EL17-011

2017 QX30; PUSH-BUTTON IGNITION SWITCH MID-YEAR CHANGE

APPLIED VEHICLES: 2017 QX30 (H15)

Figure 1

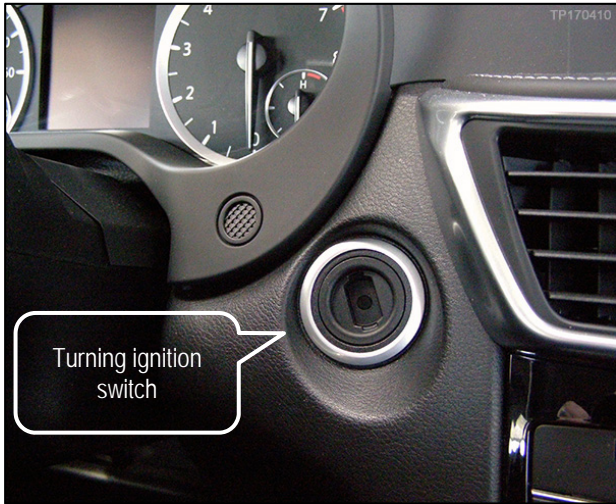
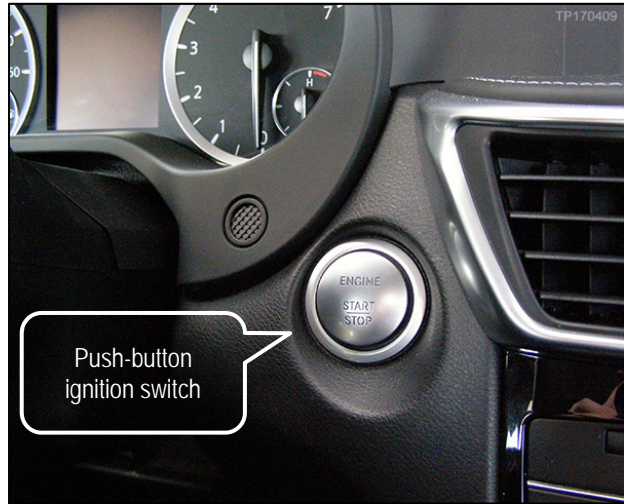
A mid-year change has been made to the ignition system in the Applied Vehicles.

Vehicles produced November 3, 2016 and after (see VIN information on page 2) are equipped with a push-button ignition switch instead of a turning ignition switch.

Vehicles built **BEFORE**
VIN: SJK(*)H5C(**)HA 029900

Vehicles built **AFTER**
VIN: SJK(*)H5C(**)HA 029899

- Do NOT retrofit the push-button ignition switch to vehicles produced before the application date. Please reference Infiniti Parts and Service Bulletin IPSB/16-422.
- Modifications to the ignition switch are unauthorized, and may violate Federal law by making inoperative a device installed in compliance with Federal safety standards.
- Damage or failure due to changes or modifications to the ignition switch system are not covered under the terms of the warranty.
- Damage or failure due to changes or modifications to the ignition switch system are not subject to indemnification under the terms of the Infiniti Dealer Sales and Service Agreement.
- Retailers may be obligated under their Sales and Service Agreement to indemnify Infiniti for any damages, injuries, or deaths caused by modification of the ignition switch system.
